APPENDIX E

COMMENT LETTERS ON THE DRAFT PEA AND RESPONSES TO COMMENTS

Comment Letter #1

Responses to Comment Letter #1
(Western States Petroleum Association, September 13, 2010)

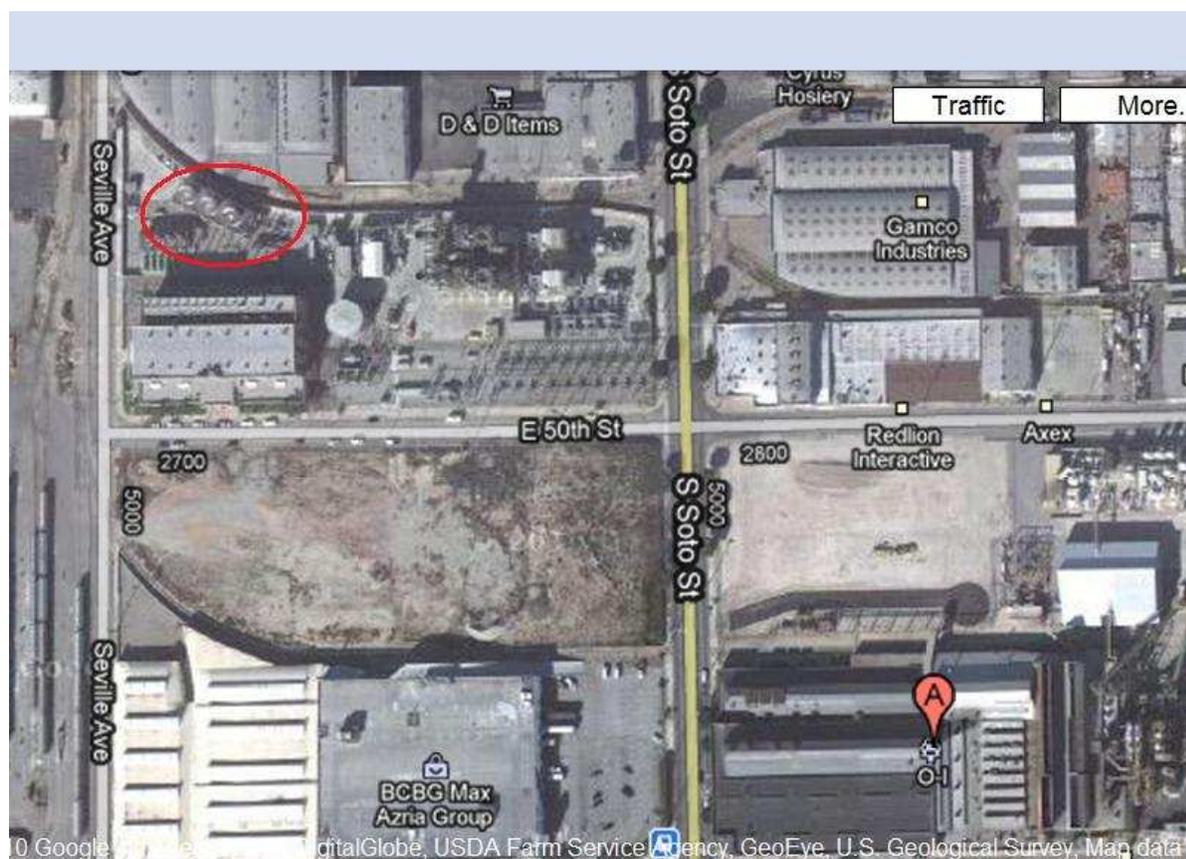
The Owens Vernon glass plant is different from some of the other facilities affected by the proposed rule in that there currently are no visible steam plumes at the facility or nearby. Therefore, the addition of a visible plume is not visually consistent with the profile of the existing facility. We also disagree that a scenic highway or corridor within the area of the melting plant is a prerequisite for a significantly adverse affect on aesthetics. It is common practice to address aesthetics impacts for a facility in an industrial area by taking photographs of the facility from various vantage points and superimposing a mockup of the potentially offending visual element (in this case, a steam plume) on each photograph. It is not acceptable to draw broad conclusions regarding an impact that was previously determined to be potentially significant in the NOP/IS without providing the decision makers the means to form their own judgment. We therefore request that the aesthetics section be revised to properly describe the impact of the proposed BARCT on the container glass sector to properly inform the District's decision makers on the visual impacts of the proposed BARCT.

2-12 While the comment states that there are no visible steam plumes at the glass melting plant or in the immediate area, SCAQMD records⁶ show that there are at least three cooling towers, which are sources of steam plumes, at Owens-Brockway and at two neighboring facilities within one mile of Owens-Brockway (Henry Company located at 5731 Bickett in Huntington Park and the Seven-Up/Royal Crown Bottling Company located at 3220 East 26th Street in Los Angeles). Cooling towers, essential to industrial and commercial processes that require heat dissipation, utilize an open wet system that relies on the latent heat of water evaporation to exchange heat between the process and the air passing through the cooling tower. As the water evaporates, a stream of saturated exhaust air, a steam plume, leaves the tower. The plume is visible when the water vapor it contains condenses in contact with cooler ambient air. Depending on a cooling tower's location and the surrounding atmospheric conditions such as temperature and humidity, i.e., in an area of typically high humidity and low temperatures (near the coast) versus an area of typically low humidity and high temperatures (inland desert areas), this water-saturated air can create a visible plume.

In addition to the aforementioned facilities, there is another facility, as shown in the following satellite photo, located near the corner of 50th Street and Seville Avenue in Vernon, approximately one block away from the glass melting plant, that currently has three visible steam plumes (as identified by the ellipse) emanating from three cooling towers⁷. These plumes are also part of the existing aesthetics setting of the area surrounding the Owens-Brockway facility. This means that if all of the cooling towers are operating, depending on the ambient temperature and humidity, visible steam plumes may be present at or throughout the area near the Owens-Brockway facility. However, as noted in the Final PEA and as illustrated in the following satellite photo, because of the existing plumes, one additional plume from each WGS installed is not expected to significantly adversely affect the visual continuity of the surrounding area of each affected facility because no scenic highways or corridors exist within the areas of the refineries, the coke calciner, the sulfuric acid plants and the glass melting plant. Further, because the plume from a new WGS is located in an industrial area and would likely be located approximately the same distance from residences, approximately ¼-mile away, compared to the existing plumes from the cooling towers, it would be no more noticeable to the closest residents than the existing plumes. Therefore, the conclusion that aesthetics impacts from implementing the proposed project would be less than significant continues to be valid.
